**EPA Superfund  
Record of Decision:**

**SENECA ARMY DEPOT  
EPA ID: NY0213820830  
OU 12  
ROMULUS, NY  
09/28/2004**

Re: Record of Decision for SEAD-27, 64A, and 66 Institutional Controls in the PID and Warehouse Area at the Seneca Army Depot Activity Superfund Site, Romulus, New York

**FINAL**  
**RECORD OF DECISION (ROD)**  
**SITES REQUIRING INSTITUTIONAL CONTROLS**  
**IN THE PLANNED INDUSTRIAL/OFFICE**  
**DEVELOPMENT OR WAREHOUSING AREAS**  
**SENECA ARMY DEPOT ACTIVITY**

FIGURE 1-2  
 EXTENT OF PID AREA  
 LAND USE RESTRICTION

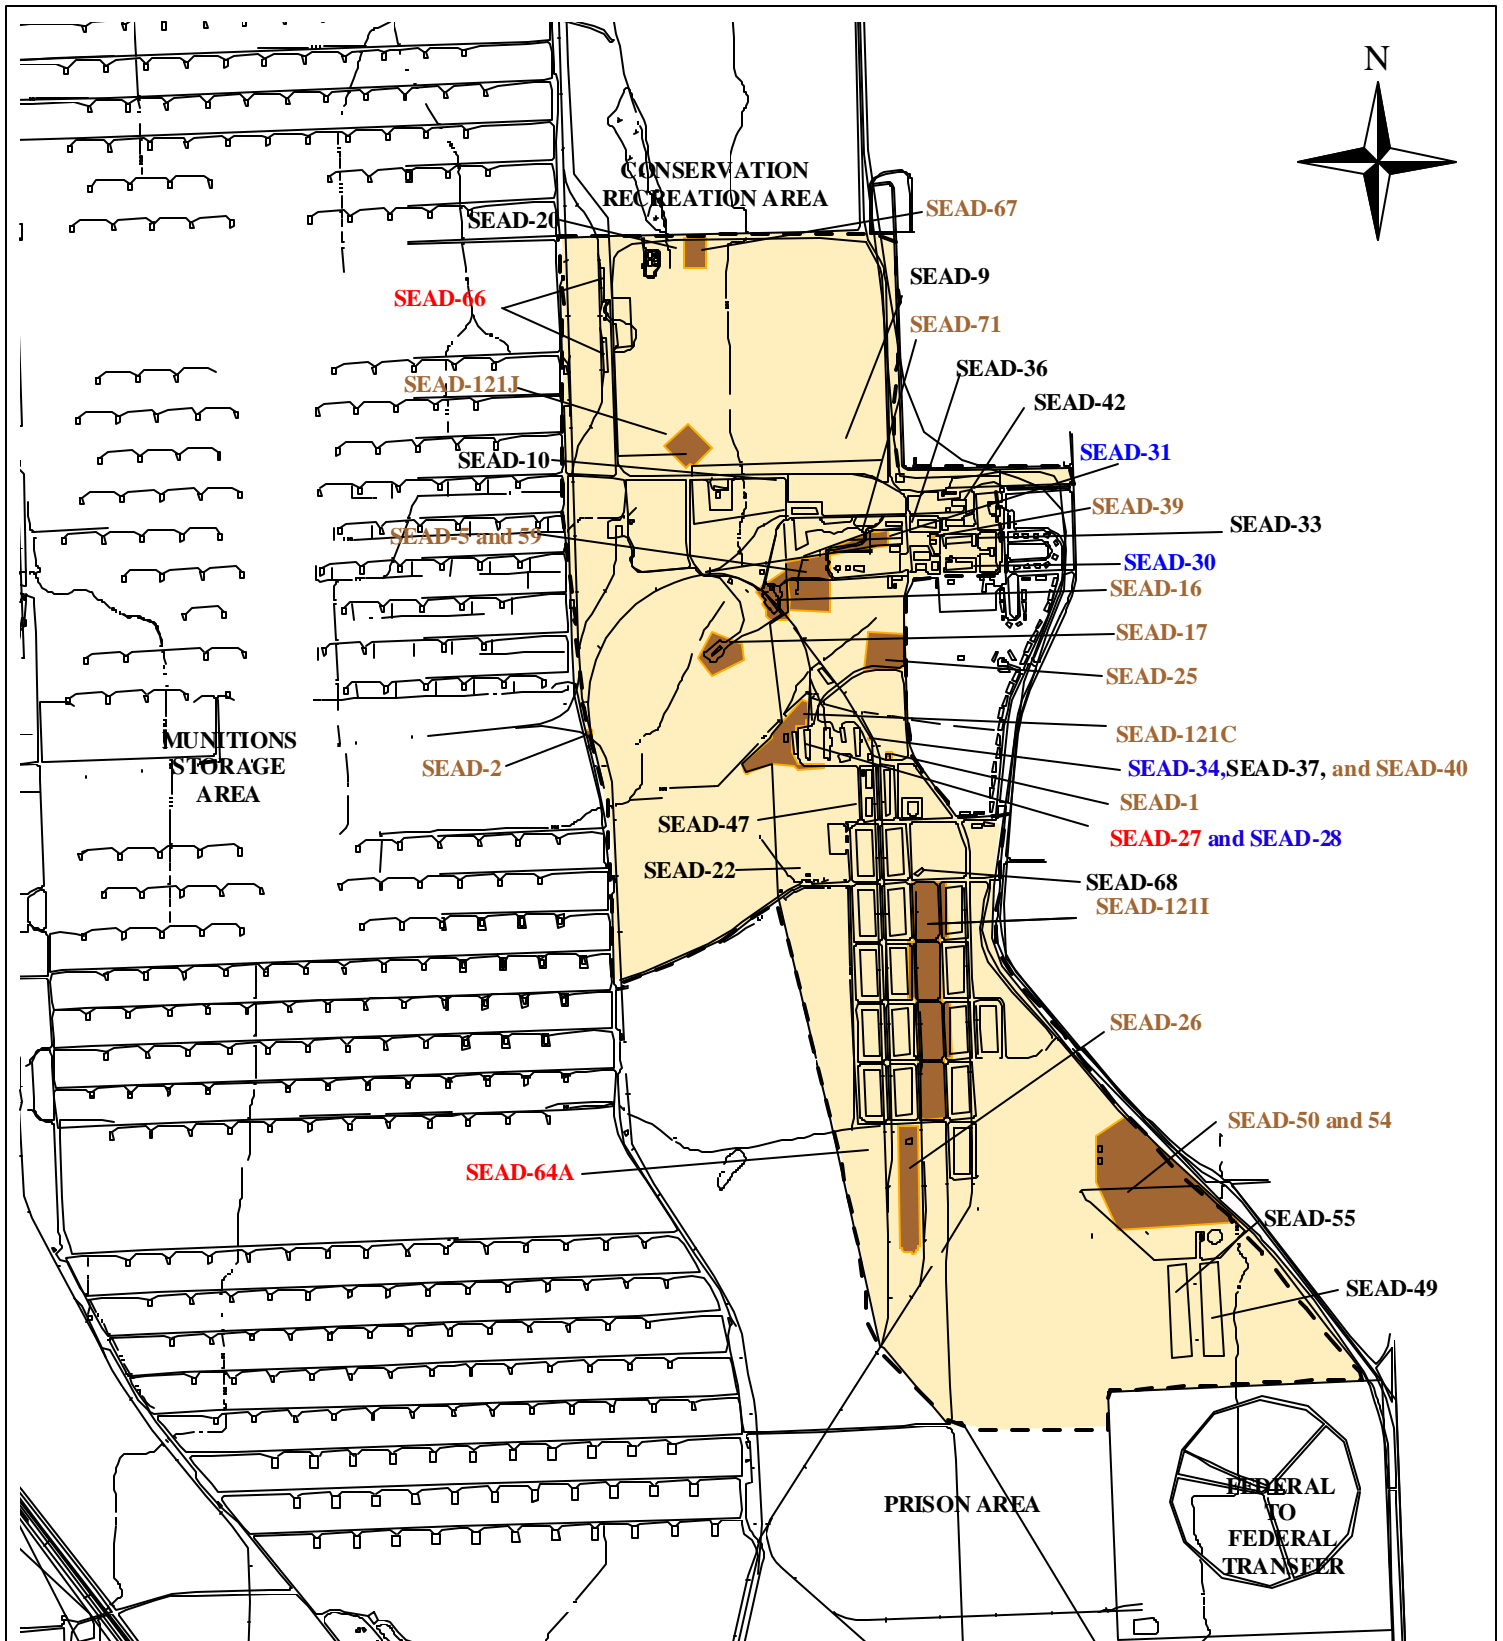
On Figure 1-2, I think the reference to "no residential activity, should include the other activities "childcare, playgrounds, elementary and secondary schools". Also, I do not see the restriction or 64A about no unauthorized excavation.

Agreed. Changes have been made to the legend of Figure 1-2 to reflect the land use restriction language that is contained within the main body of the ROD text. Additionally, the prohibition to digging at SEAD-64A has also been added.
